May Minutes

Thursday, May 3, 2018; 7:00 p.m.

The May meeting of the Historic Preservation Commission was held on Thursday, May 3, 2018 in the C. Vernon Gray room located at 3430 Court House Drive, Ellicott City, MD 21043. Ms. Tennor moved to approve the April minutes. Mr. Roth seconded. The motion was unanimously approved.

Figure 6 - Proposed windows and doors

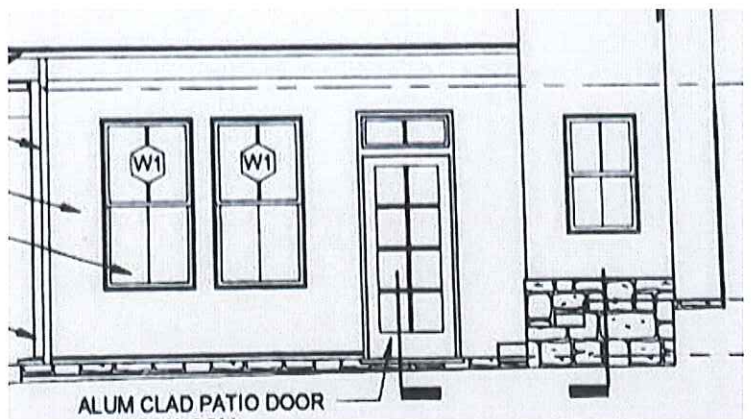
Please note the drawings incorrectly state a proposed material and door light/panel arrangement and Staff has requested the drawings be updated to match the specs provided.

Mr. Reich asked which windows were proposed to be vinyl clad wood windows. Mr. Busch said all of the new windows are proposed to be vinyl clad with full divided lights. Ms. Holmes explained that Andersen Windows calls their product a full divided light, which is a simulated divided light with exterior muntins. Ms. Holmes said simulated divided light is appropriate for this case since the elevation is not that visible from the street and the alterations will be taking place on a modern addition. Ms. Holmes said their main question was about the depth of the muntins since the product estimate did not contain that information. The Commission said the Applicant can work with Staff on approval of the muntin depth.

Mr. Reich asked if fiberglass doors will be used. Mr. Busch said yes. Mr. Reich said a wood door is more appropriate in the historic district. Mr. Busch said due to sun exposure on the west elevation, he will need to add a roof or entryway over it to protect it. Mr. Reich said the manufacturers can apply a protective coating on the door to extend the life. Mr. Reich said the polyurethane on wood will last just as long as vinyl and said that Andersen makes such product, if that is the product they are using. Mr. Busch agreed.

1. The exterior doors that were shown as fiberglass should be wood.
2. Any place where the foundation wall is exposed below the lower level be clad in the granite veneer.
3. Tax credit pre-approval for three two over two upper windows on the west elevation.
4. The three windows on the kitchen will be two over two, as opposed to the diamond transom pattern, on the east elevation and the kitchen window on the south elevation will be one over one.
5. The muntin depth to be approved by Staff.

Figure 7 - Proposed casement windows

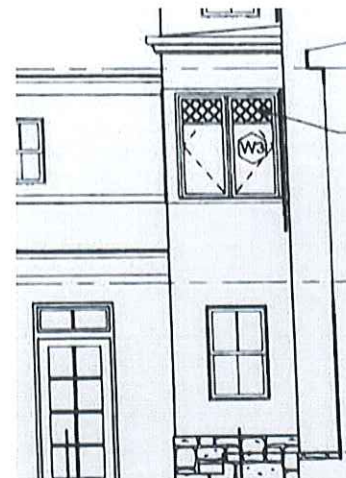
Three white vinyl clad wood casement windows are proposed to be added to the east corner overlooking the future patio. The casement windows will not have muntins, matching the design of existing historic windows on the west side of the house. Diamond patterned wood transom windows will be constructed above the new casement windows, to match the historic windows on the west side of the house.

Ms. Zoren asked if the aluminum window with lattice work on the corner is a new window proposed to be added in. Mr. Busch said the window, which is shown on the elevation, would be located on an older addition that could be around 100 years old, it is not part of the 2000 addition. Ms. Zoren said the two diamond windows proposed in the corner looked out of place from the rest of the windows, which appears to have 2 over 2 windows. Mr. Busch said the intention was to match the diamond pattern on the windows on the west side of the house. Ms. Zoren thought it would make more sense if the new

windows were on the same elevation as the historic windows, but looked out of place on the different addition. The Commission recommended using two over two windows, to match the width of the window below it on the east elevation. Mr. Busch was ok with the recommendation. Mr. Reich asked which elevation is visible from Hill Street. Mr. Busch said the visibility is from all sides being on a hillside, but the east elevation is less visible.

Figure 8 - Proposed east/northeast elevation

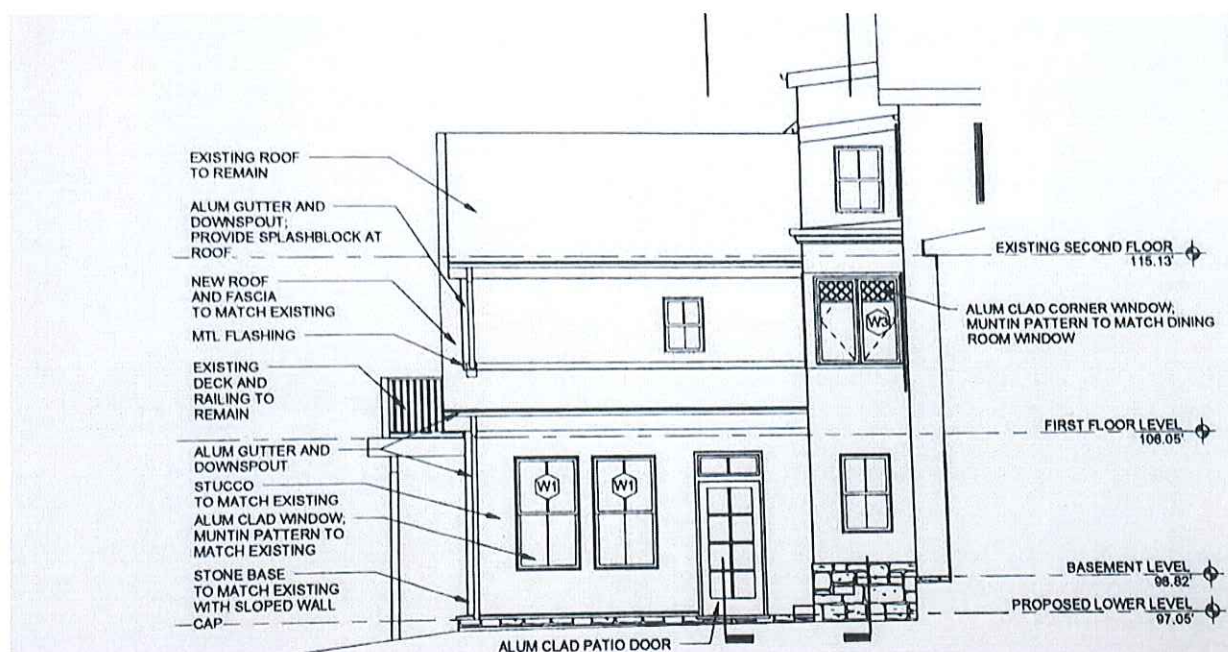
On the ground floor, two 2:2 white simulated divided light vinyl clad wood windows (31" wide by 54" high) will be installed on the northeast elevation. A new fiberglass over a graphite polystyrene core, 10-light single French door with a transom, will be installed next to the windows. The application states the windows will be full divided lights (not true divided lights), which is a term Anderson has coined for their simulated divided lights with an aluminum spacer between the glass.

Figure 11 - Proposed west elevation

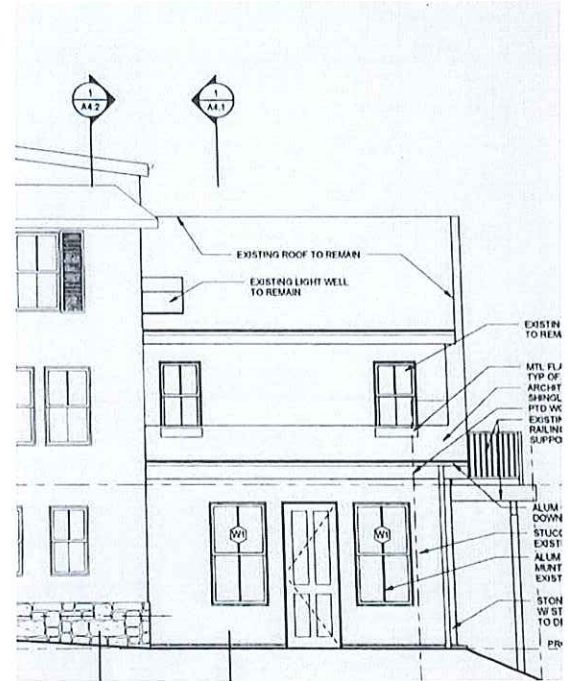
Two 2:2 white vinyl clad wood double hung windows (31" wide by 54" high) will be installed on the west elevation of the existing addition on either side of a new door. The new door will be a white 6-paneled door. The 6-panel door will be from Feather River. The material is not completely evident but appears it may be Fiberglass based on the information available from the manufacturer's website.

Based on the drawings and photos of the existing conditions, there may be some grading and/or fill happening in order to make this area level. Clarification on this is needed and whether or not a retaining wall will be needed. The HVAC unit will also need to be moved for the proposed changes and the new location will need to be identified and approved.

The new doors (10-light single French door and 6-panel solid door) will be Fiberglass. It would be preferable to use historic building materials to best comply with the Guidelines, such as a wood door, on the most visible west elevation. The single French door on the east elevation will be minimally visible, but the west elevation is highly visible.

Mr. Reich asked Staff for clarification on the grading and fill issue. Ms. Holmes said the west elevation had a steep grade change from the street and showed the rendering of the elevation, which showed flat ground. Ms. Busch said he plans to use block foundation with granite veneer where the foundation is exposed. Ms. Holmes asked if there will be fill in the area. Mr. Busch said yes. Ms. Tennor said the location of the existing AC unit will become a new door. Ms. Tennor asked where the AC will be relocated. Mr. Busch said the AC unit will be relocated behind the tree. Ms. Tennor asked how using granite foundation cladding will resolve the grading issue. She asked if it will need to be more level than it currently is. Mr. Reich says it will need to be more level where the door will go. Ms. Tennor asked if he anticipates doing grading at the corner. Mr. Busch said he anticipates minimal grading that could be held up with groundcover. He said that if a retaining wall was needed, he would return to the Commission for approval, but they don't want to install a retaining wall if they don't need to. Mr. Reich said anything below the floor level would be a foundation wall covered with granite. Mr. Busch said yes.

Mr. Taylor asked about using wood windows on the west elevation. Mr. Busch said the two existing upper windows on the west elevation are vinyl 6 over 6. Ms. Holmes asked if these windows will be replaced. Mr. Busch said not at this time. Mr. Reich asked if the Applicant is willing to use wood windows on the west elevation. Mr. Busch said he preferred vinyl but will use wood based on the Commission's recommendation.

Motion: Mr. Reich moved to approve the application with the following amendments: The two windows on the lower part of the west elevation be wood.

Figure 13 – Proposed shed roof dormer on enclosed rear porch

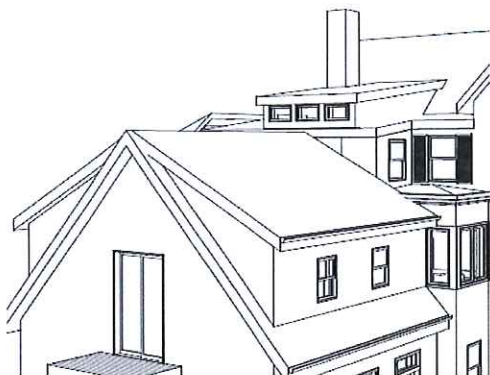
There is a former enclosed porch on the second story at the rear of the house where the historic house ends and the addition begins. The Applicant proposes to install a shed roof dormer at this location in order to increase the existing ceiling height, from 6'0" to 8'0". Three small awning windows with a muntin bar in the center of each window, will be installed. See Figures 13 and 14.

Mr. Reich confirmed that they are adding on to the gable end of the existing roof to create the pitch of the roof that will look like a shed dormer. Mr. Busch said yes. He said if they had new construction this is not the approach they would be taking, but are doing so as a result of the existing addition. Ms. Tennor said the proposed work will make the building look much better.

Figure 15 – Patio doors that are not currently proposed

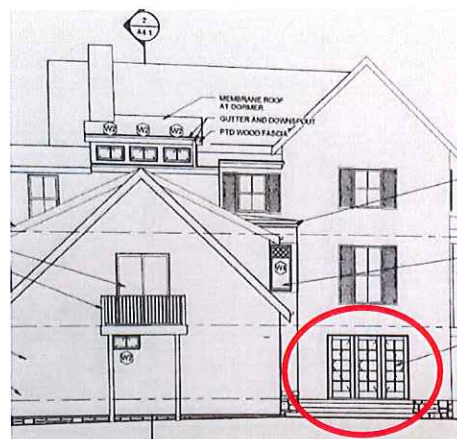
The application explains that the proposed patio and triple patio doors shown on the plans (Figure 15) are not part of the current application. These items will be subject to a future application for Certificate of Approval if the Applicant decides to build them.

Figure 17 - Revised elevation for May 2018

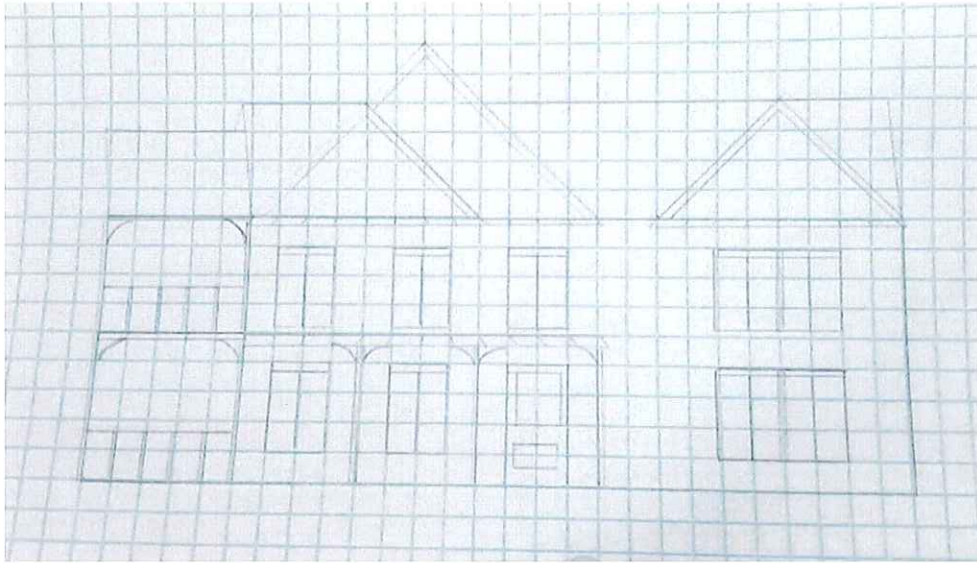
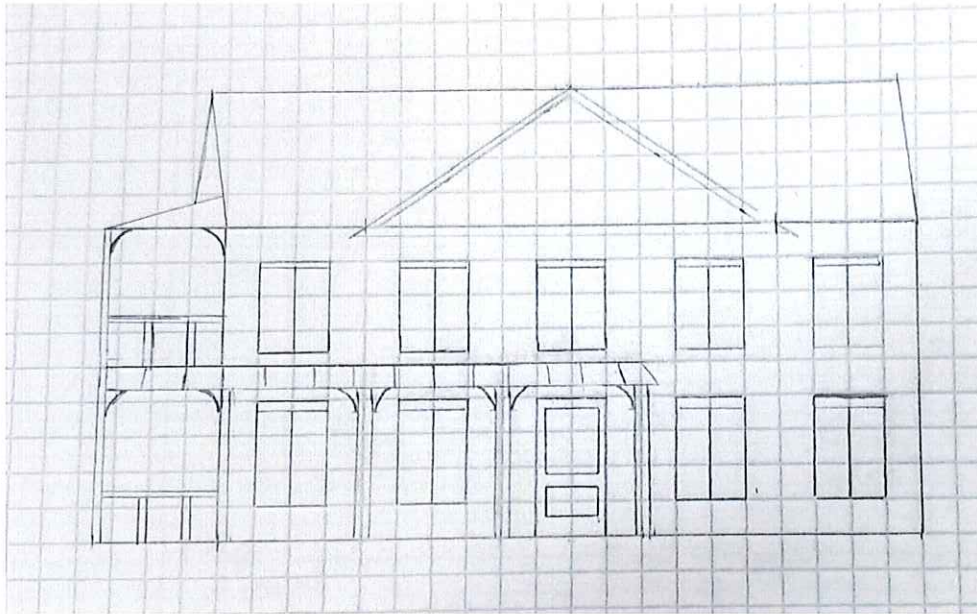
Staff Comments: The overall reduction in width is minimal and not highly noticeable. While the Applicant removed the dead space and multiple gables from the April front facade, the structure is still proposed to be 5 bays wide, which is wider than any house on the street. New construction should blend in with the neighboring historic structures and not stand out. The proposed building is still significantly wider, at 47 feet (including the side porch) than the neighboring historic structures, which range approximately from 30 feet to 39 feet in width. Reducing the house 10 feet in width would make the new structure compatible in width with the neighboring historic structures.

The sketches provided are very rudimentary, so there are not many details to evaluate. However, the front porch only covers $\frac{1}{4}$ of the front façade, which is not balanced. The front porch should run the full

width of the house, which better complements the majority of the historic structures on the street. The porch roof is shown as shed roof, similar to that found on 3612 Fels Lane, but a hipped roof would be more appropriate for a wrap around porch. However, these are details that can be further examined when the required drawings are submitted for a Certificate of Approval.

The design of the windows may also contribute to the overall appearance of the wide front façade. The windows drawn on the sketch would indicate they are proposed to be casement windows versus double hung. An appropriately scaled double hung window, which is found on all houses on the street (1:1 or 6:6), would be a more appropriate to have on the front façade of the proposed new house.

At the April 2018 meeting the Commissioners explained that the sketch provided is drawn as though the house would be sitting on level ground, when in reality there is a very steep slope at this location. The new sketch still assumes a level building surface, so it is not representative of the actual building situation.

Staff Recommendation: Staff recommends the overall footprint be reduced at least 10 feet in width in order to fit in with the neighboring historic structures. Alternatively, Staff recommends rotating the footprint of the house 90 degrees to allow the shorter length of the house to front on Fels Lane.

1. Utilize the basement and subbasement as living space.
2. Shrink the footprint to minimize site and construction costs and environmental impact.
3. The design should be more compatible with other historic houses in the neighborhood.

Figure 27 - 1976 photograph from neighboring HO-141 National Register nomination form

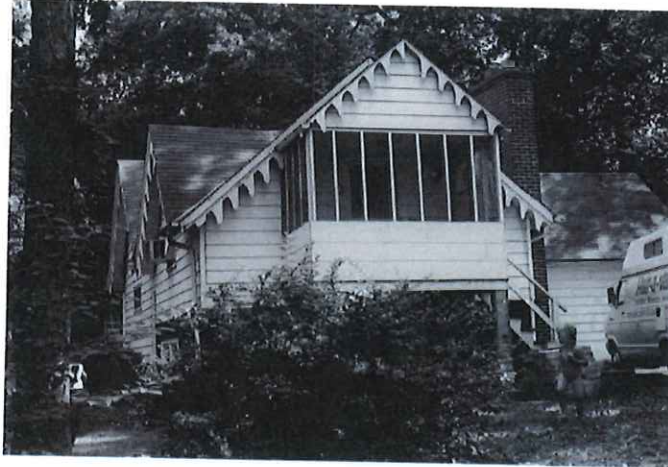
The Applicant proposes to paint the house brown with green trim. The house currently has white siding on one side and brown siding on another (see Figure 26). There is a first-floor door that is blue and a second story door that is green (see Figure 25). Staff recommends all the siding be painted white and

the doors green. The house appears to be white in the 1976 photograph in Figure 27 and there is a historical precedent for keeping that color scheme. The brown appears to have been painted at some point without approval.

- 1) Replacement of the existing green asphalt shingle roof with the proposed Tamko 3-tab green asphalt shingle to match the existing.
- 2) Reconstruction of the front gable to match the dimensions of the previously existing.
- 3) Reconstruction of the porch with Douglas Fir wood, with square posts and balusters, painted green.
- 4) Replacement of siding with GAF Weatherside fiber cement siding, to replicate the asbestos siding, to be painted white with green trim.
- 5) Repair the existing doors.
- 6) Replacement of the broken metal window with a wood Marvin window.
- 7) Replacement of the wood bargeboard, to be painted green, to match the existing in material and design.
